## **Product Change Notice (PCN)**

PCN Number: PCN-0450879R-01

Product(s) Affected: PJ1-021

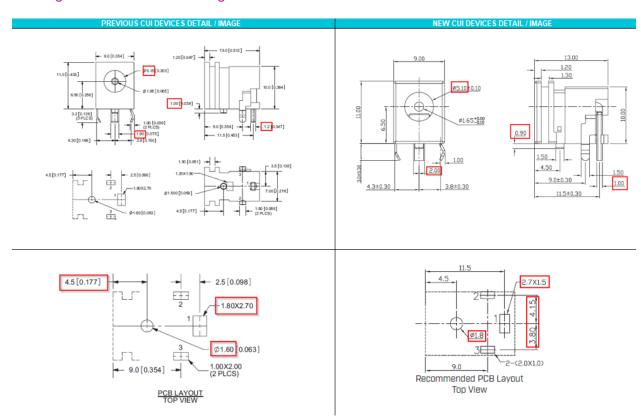
Description of Change: Minor Housing and footprint differences. Material Change on the housing and terminals. See image Below

PRI	EVIOUS CUI DEVICES I	DETAIL / IMAGE			NE	W CUI DEVICES DET	AIL / IMAGE
	MATERIAL	PLATING			DESCRIPTION	MATERIAL	PLATING/COLOR
center pin	copper	silver			center pin	brass	nickel
terminal 1	copper	silver			terminal 1	brass	nickel
terminal 2	copper alloy	silver			terminal 2	bronze t=0.30	silver
terminal 3	brass	silver			terminal 3	brass t=0.40	silver
plastic	PBT				housing	PBT (UL94V-0)	black
- \$\phi_{\phi 1.7}^{\phi 4.75}\$				Ø1.7			
	MATING PLUG ertion Depth: 8.5	mm			Jack I	MATING PLUG nsertion Depth 8.7	mm
